<b>DOCKETED</b>	
<b>Docket Number:</b>	25-OPT-02
<b>Project Title:</b>	Prairie Song Reliability Project
<b>TN #:</b>	268944
<b>Document Title:</b>	Save Our Rural Town Comments - Scoping Comment letter and Attachments 1-5 submitted by Save Our Rural Town
<b>Description:</b>	N/A
<b>Filer:</b>	System
<b>Organization:</b>	Save Our Rural Town
<b>Submitter Role:</b>	Public
<b>Submission Date:</b>	3/4/2026 4:35:54 PM
<b>Docketed Date:</b>	3/4/2026

Subject: Scoping Comments by Save Our Rural Town (SORT) pertaining to the AB-205 Application Submitted for a Proposed Battery Energy Storage Project in Acton, CA.

Reference: California Energy Commission Docket Number 25-OPT-02.

Figure 3. Excerpt from the AV Area Plan “Scenic Drives Map” Showing Soledad Canyon Road is a “Priority Scenic Drive.

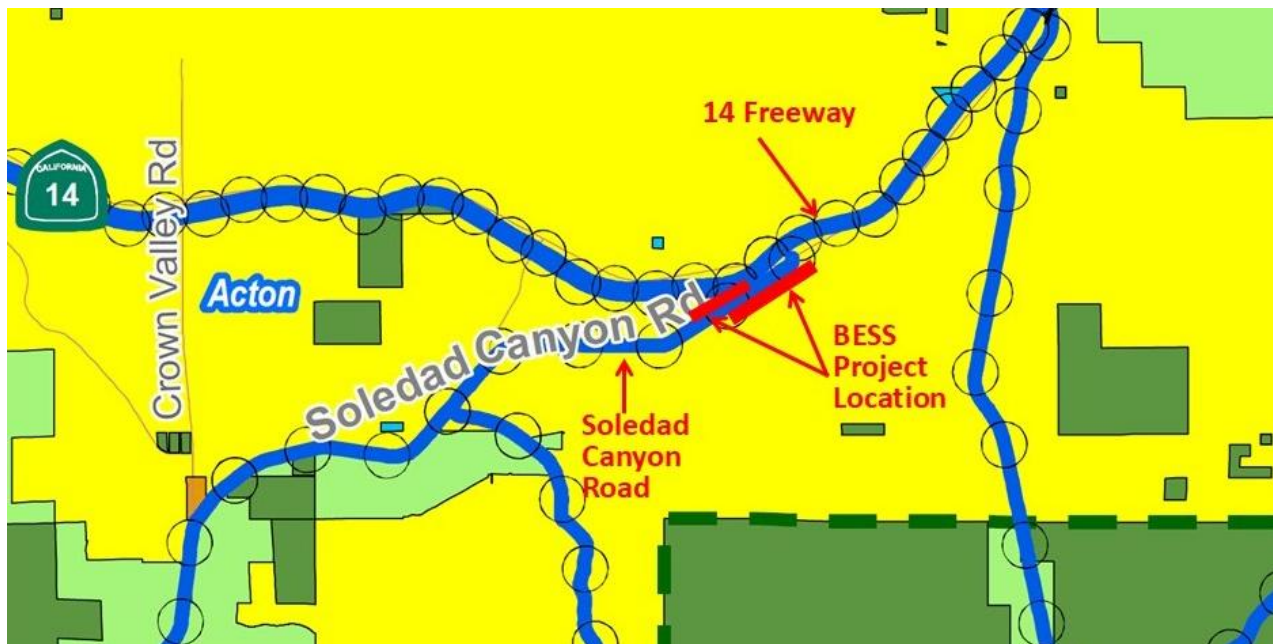
SORT appreciates that the NOP recognizes the 14 Freeway as a “priority scenic drive”; however, careful inspection of the “Town and Country Scenic Drives” Map provided in the AV Area Plan (specifically, Map 4.2) shows that Soledad Canyon Road (which runs through the BESS project) is also a “priority scenic drive”. This is demonstrated in Figure 3. SORT asks that the EIR prepared for the BESS Project recognize that Soledad Canyon Road is also a “priority scenic drive” and that construction of an enormous, tall, and unsightly industrial 500 kV substation along Soledad Canyon Road will particularly and devastatingly mar this important scenic resource in Acton.
